**TECHNICAL EVALUATION REPORT
PUMP AND VALVE INSERVICE TESTING PROGRAM
SURRY POWER STATION UNITS 1 AND 2**

Docket Numbers 50-280 and 50-281

Published July 1994

**Idaho National Engineering Laboratory
EG&G Idaho, Inc.
Idaho Falls, Idaho 83415**

FIGURE 1
FLOW VERSUS CONDENSER DIFFERENTIAL PRESSURE

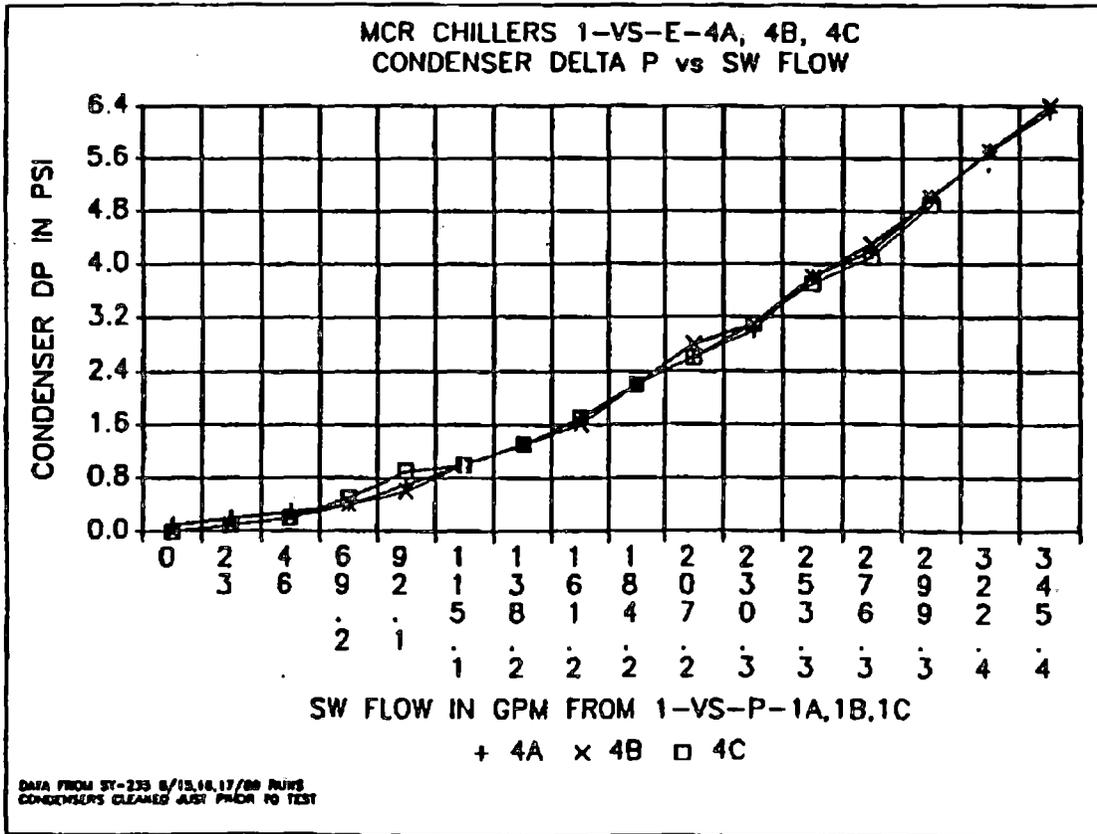
2.4.1.1.2 Evaluation--The Code requires measurement of pump d/p and Q during quarterly pump testing. The Code states alert and required action ranges for these test parameters in Tables 3a and 3b. These chilled water pumps provide cooling flow to the MCR and are not equipped with instruments to measure either inlet pressure or Q. Therefore, direct measurement of these parameters is impractical. The MCR ventilation system is common to both plants. Installation of flow rate instruments would require an extended system downtime, which would likely exceed the TS allowable outage time for the system and would be burdensome to the licensee. The licensee will add two additional chillers to the system by the end of 1993. This change will eliminate the need to enter an action statement to install instruments. Instruments for measuring inlet pressure and Q will be installed during an upcoming refueling outage, which is scheduled for early 1994.
